UNITED STATES
DEPARTMENT OF THE INTERIOR
BUREAU OF LAND MANAGEMENT

FORM APPROVED
OMB NO 1004-0135
Expires July 31, 2010SUNDRY NOTICES AND REPORTS ON WELLS
Do not use this form for proposals to drill or to re-enter an abandoned well. Use form 3160-3 (APD) for such proposals.

PROPOSED PLUGGING PROCEDURES

Well Name	Lea D #2
API No	30-015-05412
Spud Date	11/17/1960
WBD Update:	6/20/2012 JC

PROPOSED Wellbore Diagram

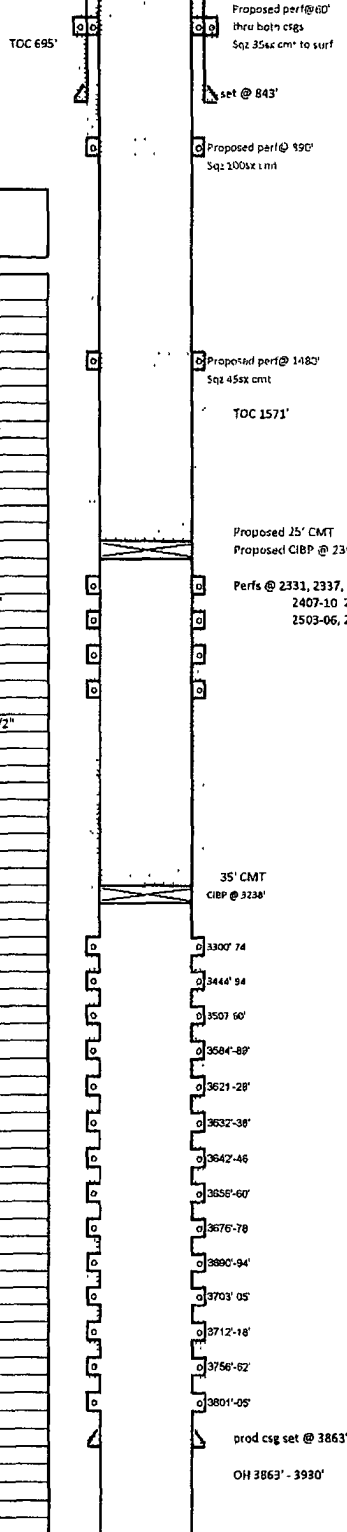
At Cut-off verify cmt to surface, all annulus. Radial cmt may be needed on 8-5/8" Annulus.

Ground Level Dry Hole Marker Reg.
